ROCKSTREAM DRIVE ASSESSMENT DISTRICT - 2020

CONTRACT NO. 8498

PROJECT NO. 12694

STORM DETAIL 2: CULVERT RAILING DETAILS

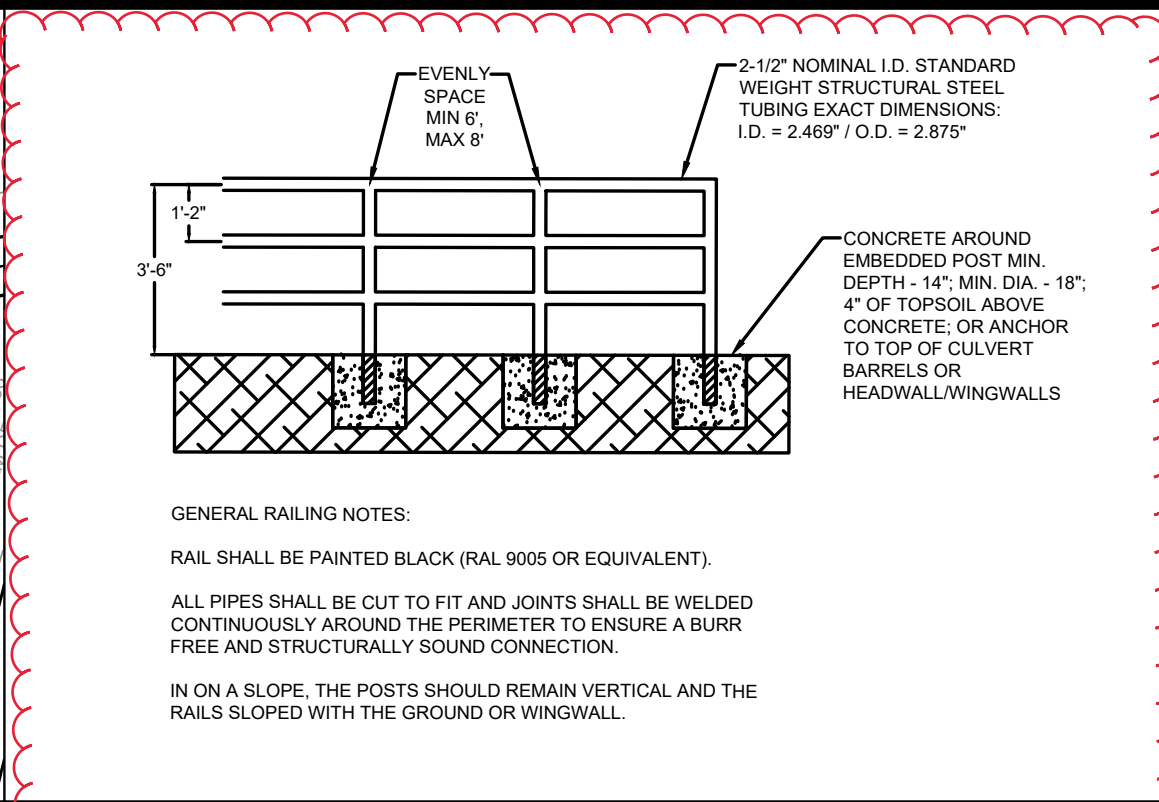
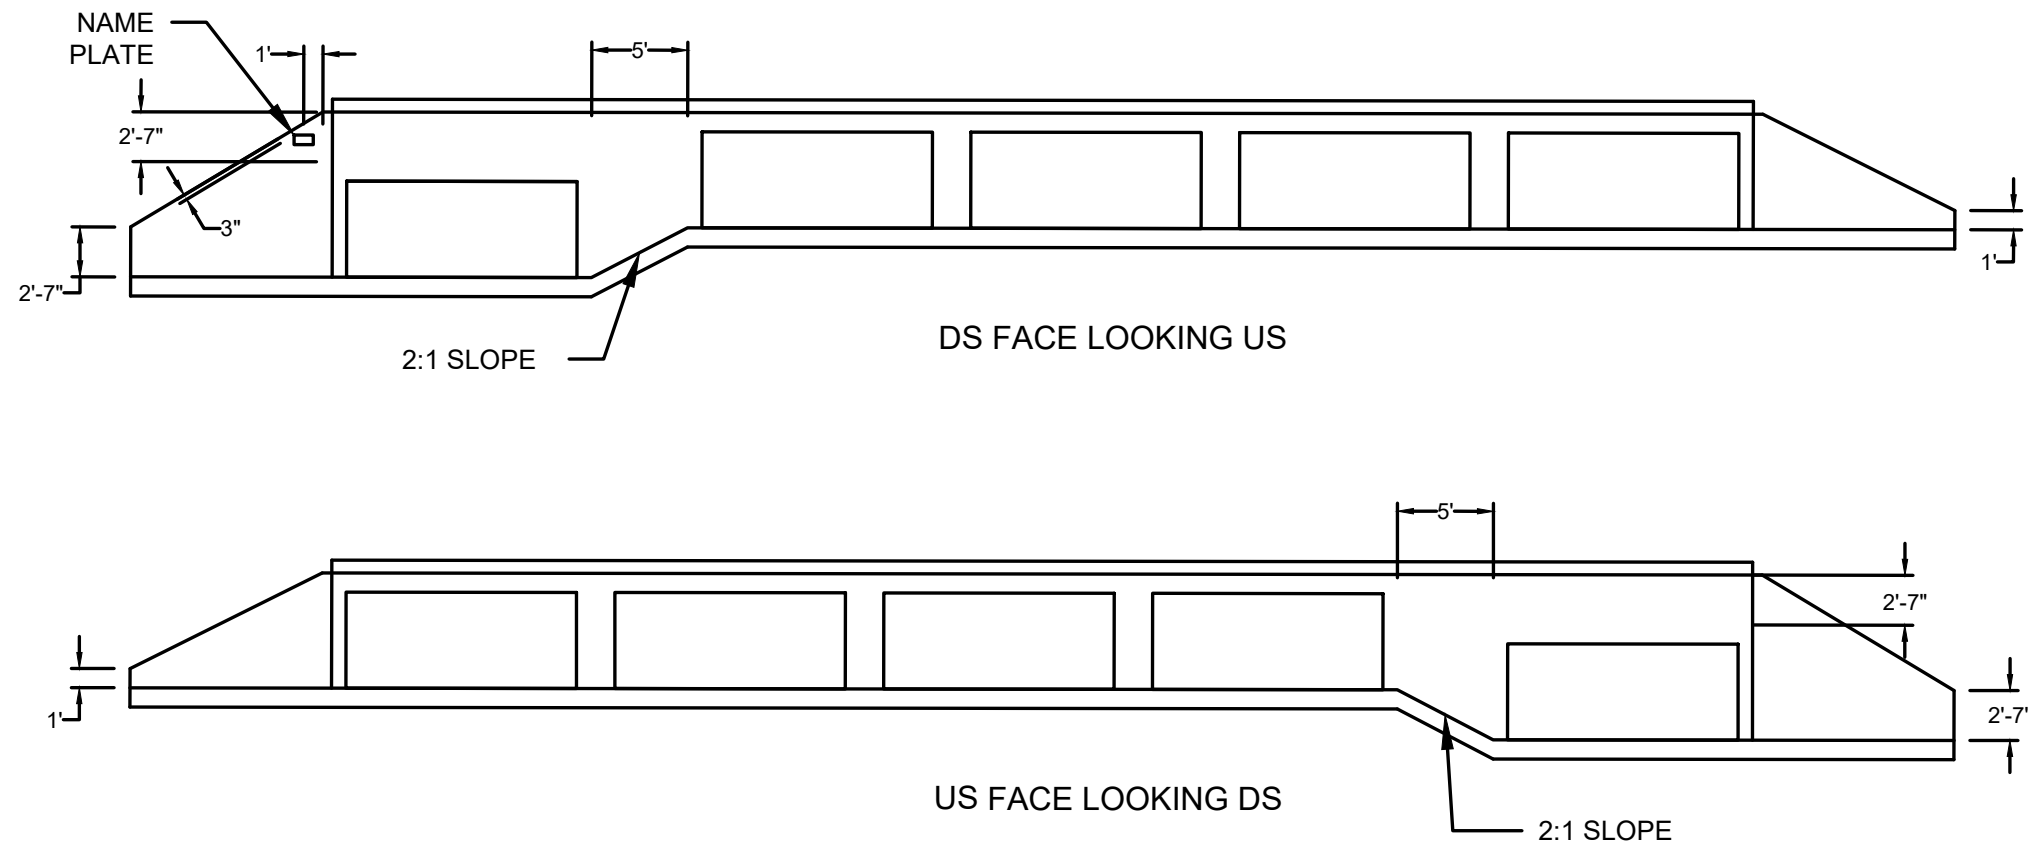
U-7: Railing detail added.

| 1 | ADDED RAILING DETAIL | 11/13/2020 | |

**TYPICAL SECTION
 ROCKSTREAM DRIVE
 STA 116+58.18 TO STA 122+79.54**

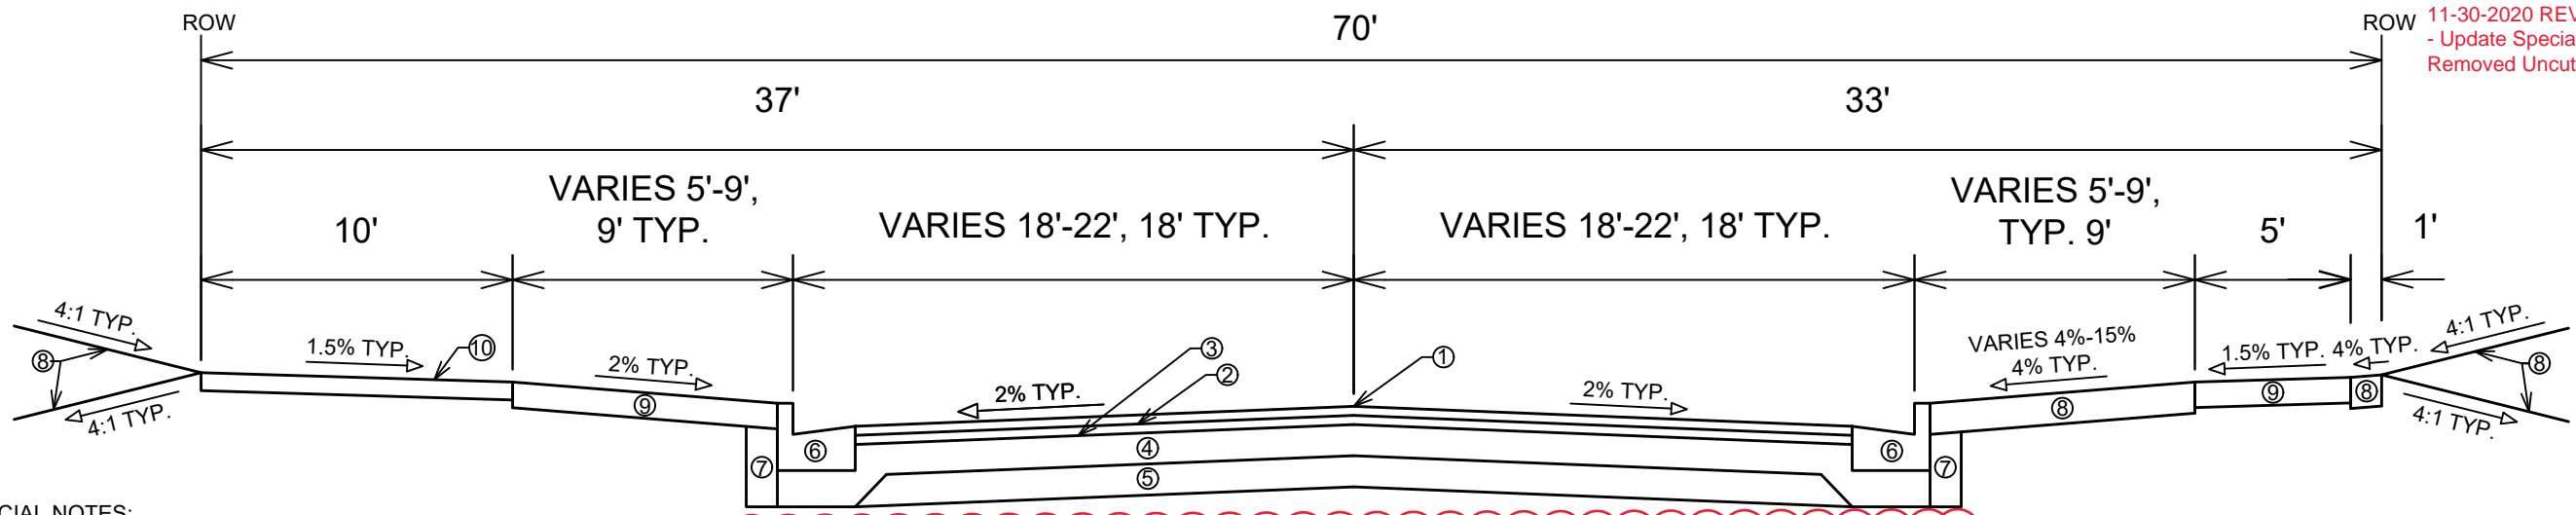
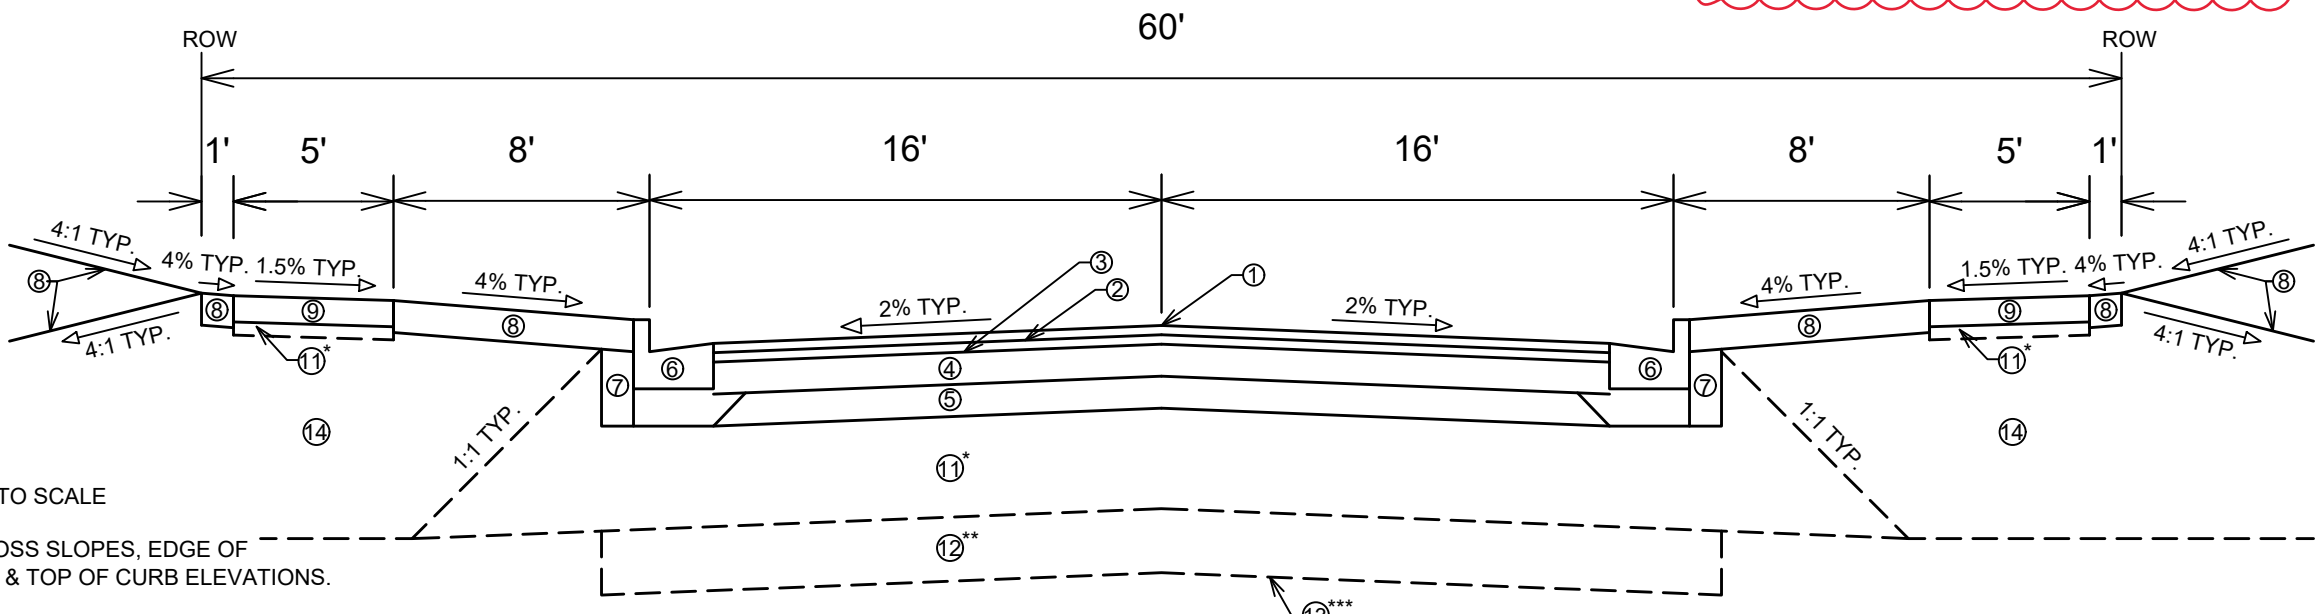
D-2: Update special notes and remove uncut information on Rockstream STA 116+58.18 to STA 122+79.54.

11-30-2020 REVISION AJZ
 - Update Special Notes &
 Removed Uncut Information

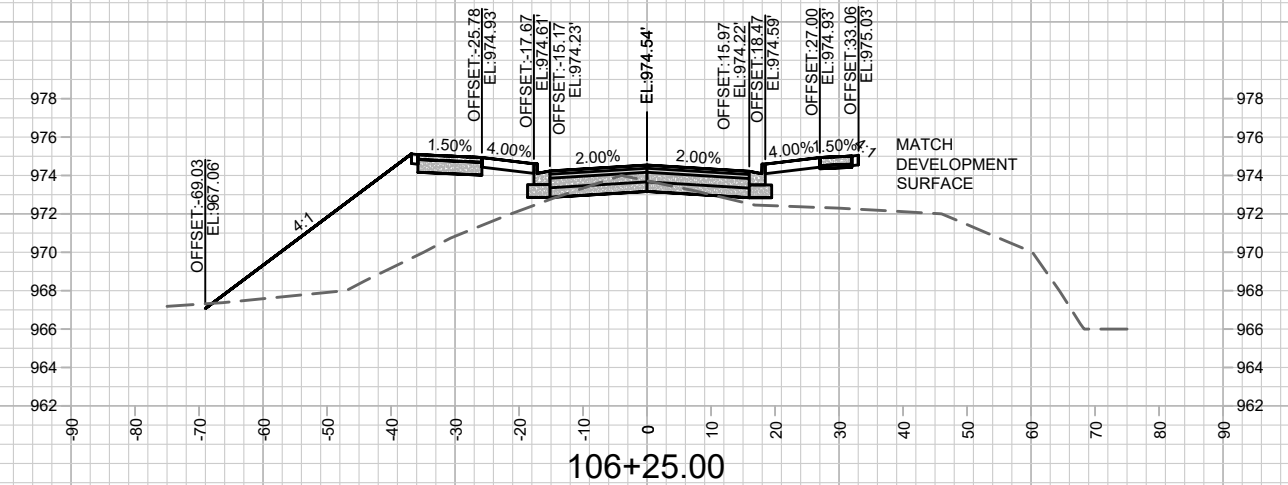
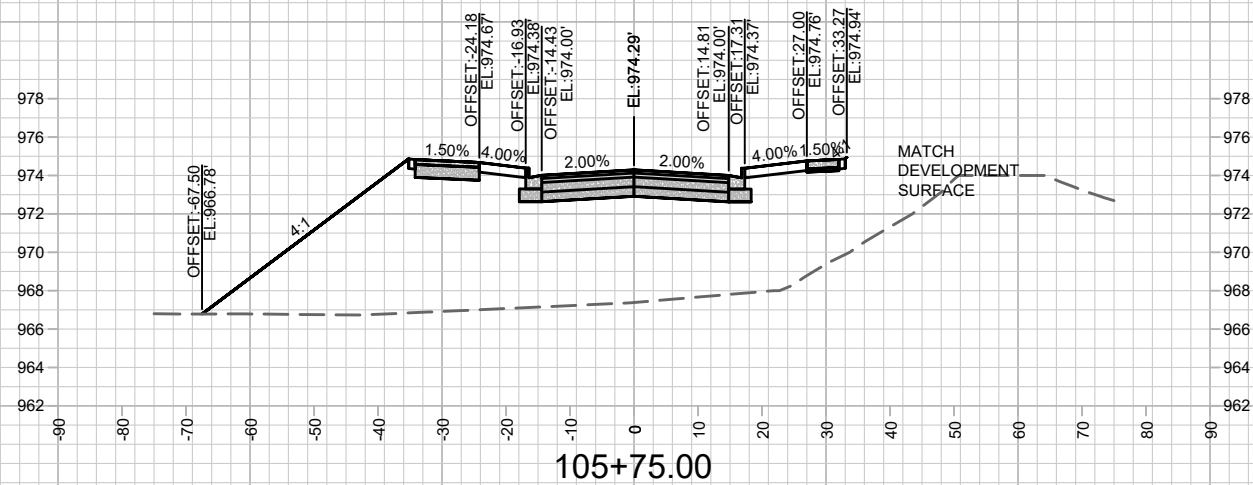
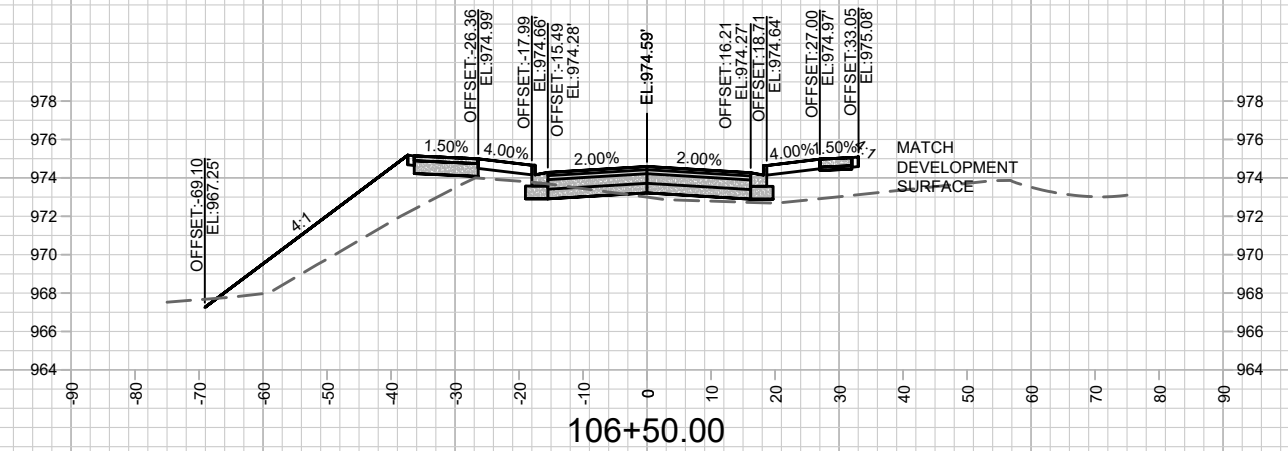
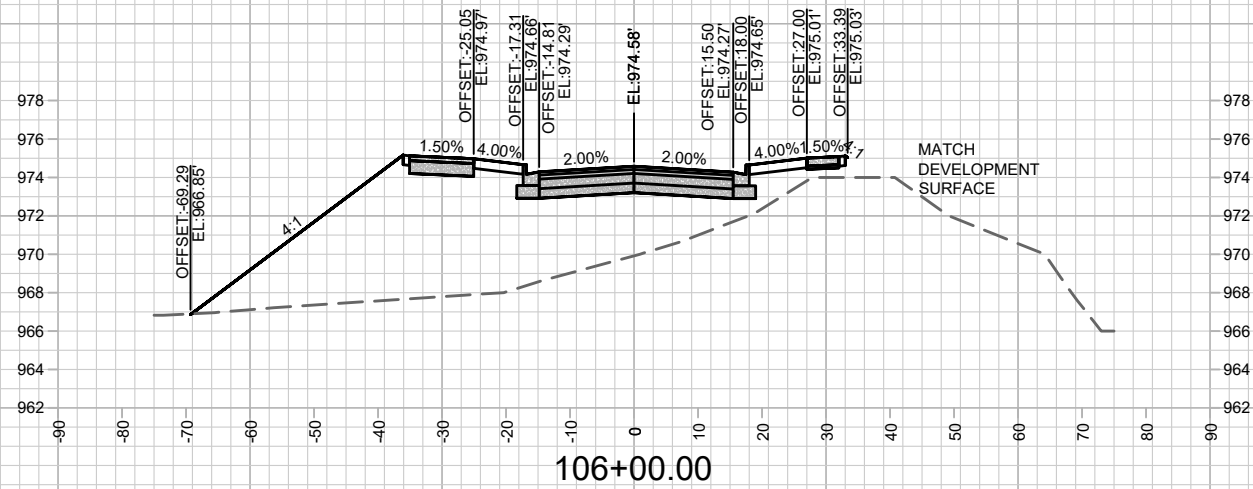
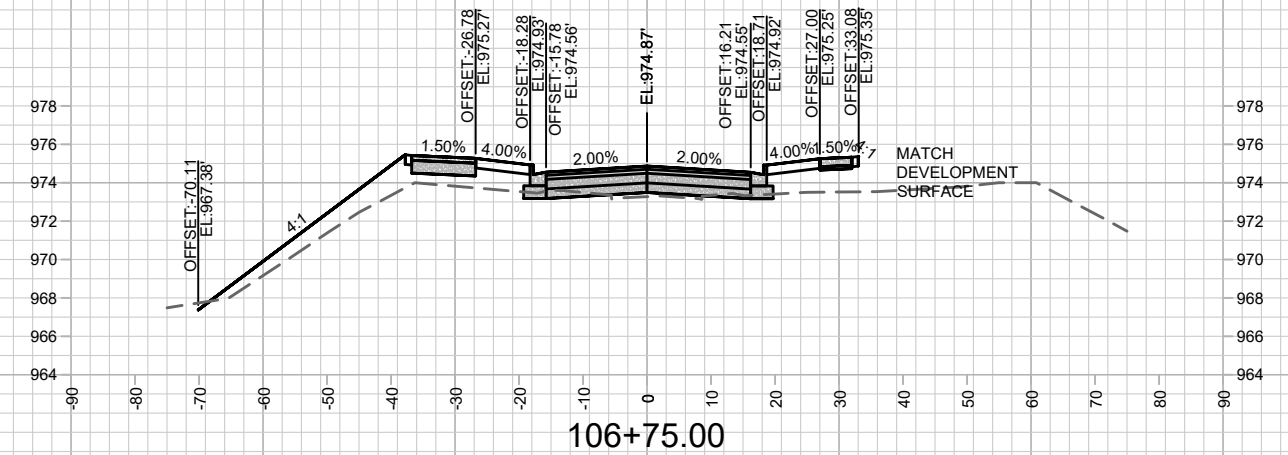
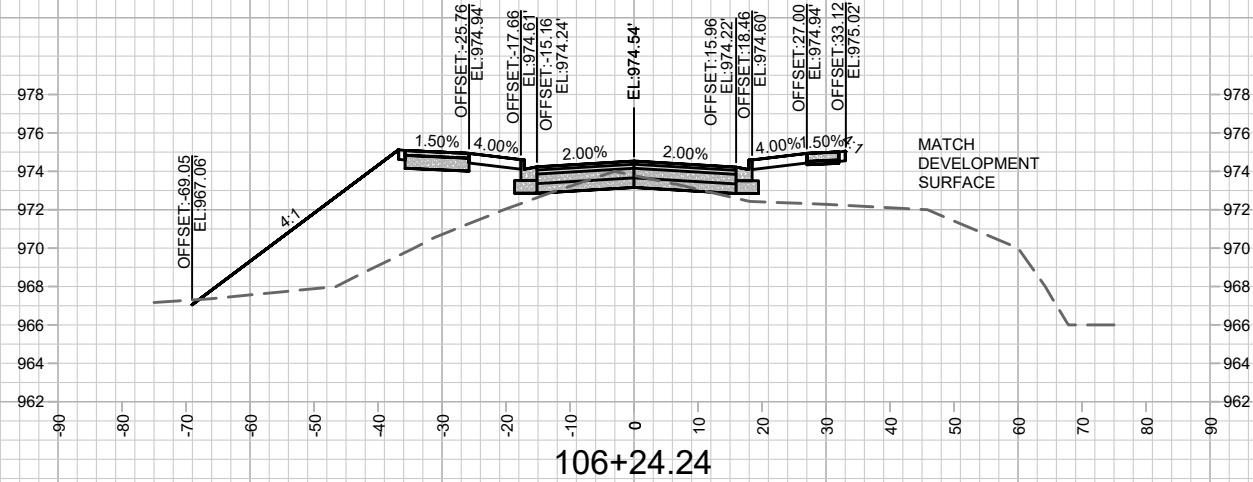
U-9: Revised note for structure S6-A in storm schedule.
